STAFF REPORT: 5/12/2021 MEETING

APPLICATION NUMBER: #21-7215

ADDRESS: 1670 BAGLEY

SCOPE: FRONT/SIDE PORCH MODIFICATIONS, WOOD FENCE INSTALLATION, PAINT

Site Photo 1, by Staff April 27, 2021: (Sout) front side

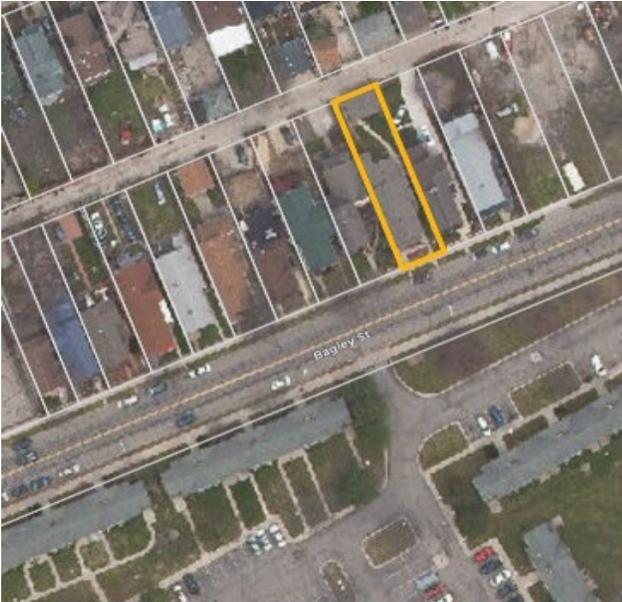
- Arching roof corbels of the front porch, sweeping roof design, and the arched window are distinct character defining features of the house.
- Porch columns and railing are not original from the designation photo of 1985.

- Front porch deck does not appear to be its original size from the designation photo. Staff observes that the deck may have been resized by extending the deck dimensions beyond the drip-line of the front porch roof, thereby causing potentially additional wear and tear to the wood deck surface.

- It is Staff's opinion that relocation of the front steps to center with the front door is an appropriate change due to the context of neighboring porches that also have their front stoop centered to their front door.

- Trex composite material is not an appropriate material for a front elevation of the house for Corktown. Staff has the opinion that a less public location, such as the side elevation porch, may be an appropriate use of Trex decking material due to its lack of public visibility. Staff recommends repair of wood deck materials, especially at the front elevation, rather replacement of wood decking with composite material decking.

- The proposed moving of the railing of the front porch outward by 5" will create a disharmonious gap between the porch roof posts and the new railing.

Staff finds that the replacement of wood decking and stairs with composite material and moving the front porch railing at the front elevation of the house does not retain the historic character of this property and removes distinctive features of the property, and introduces a material and design that does not retain the historic character of the property. Staff therefore recommends that the Commission issue a Denial for the proposed replacement of wood decking and moving the front porch railing as they do not meet the Secretary of the Interior's Standards for Rehabilitation, specifically Standards:

- Relocation of the front stair, entrance walkway and front gate to center with the front door.
- Replacement of front porch decking, stairs, railings, spindles, skirting and newels with wood, maintaining existing dimensions.
- Replacement of square with rounded finials as described in this proposal.
- Painting of surfaces as described in this proposal.
- Replacement of chain-link fence with wood picket fence at same height, painted white.
- Installation of new proposed porch lights at locations in proposal.

- The applicant shall provide final specifications for light fixtures that are similar in dimension and material to existing light fixtures for HDC staff review and approval prior to a permit being issued.
- The applicant presents HDC staff with a front porch plan that confirms use of wood material for decking and stairs, and confirms design and locations of proposed railings.
